CHARTER TOWNSHIP OF YPSILANTI

REGULAR MEETING AGENDA

**Staff Report
Round Haus Party Shoppe
5970 Bridge Road
Preliminary Site Plan**

RE: **Round Haus Party Shoppe**
Preliminary Site Plan Review #1

SHEET
C4.4

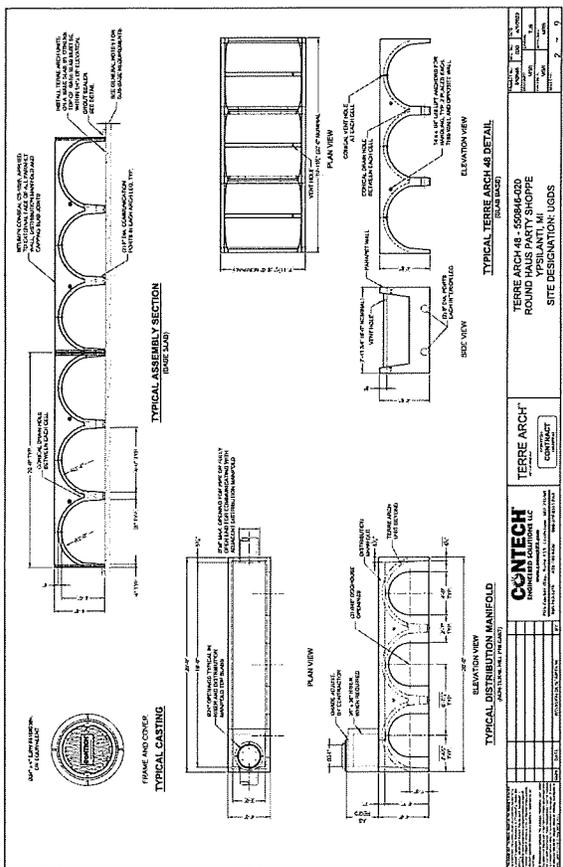
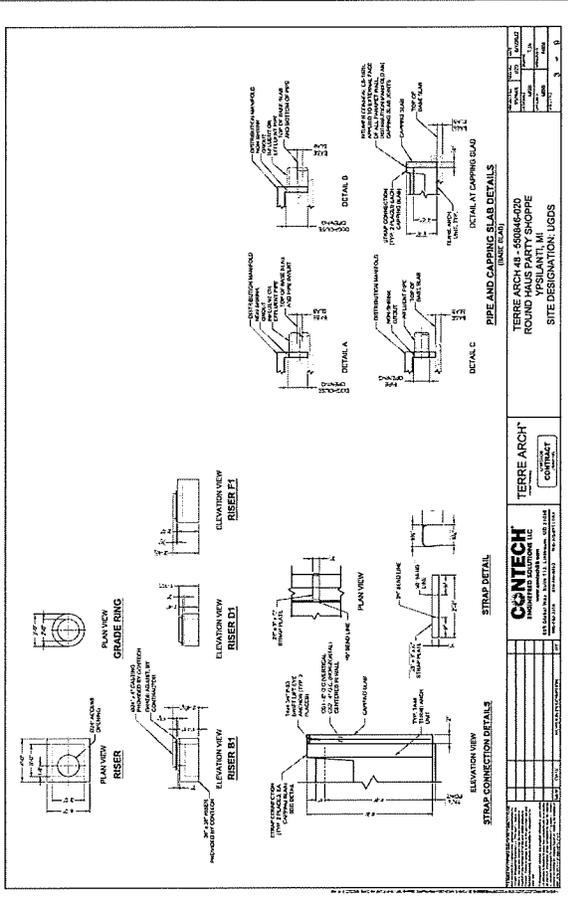
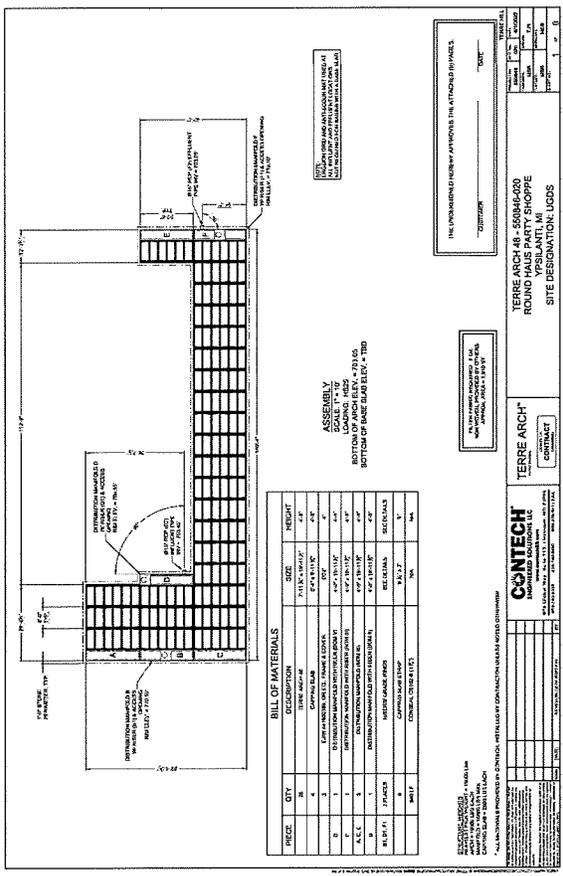
1. The applicant shall review the proposed elevations within the profiled Terre Arch Storage Tank (Sheet C4.1). It is recommended that inverts for the proposed tank be reviewed to accommodate for the proposed bottom of tank design. Furthermore, the applicant shall review the tank profile to be consistent with the proposed top of tank elevation and to avoid confusion in the field.
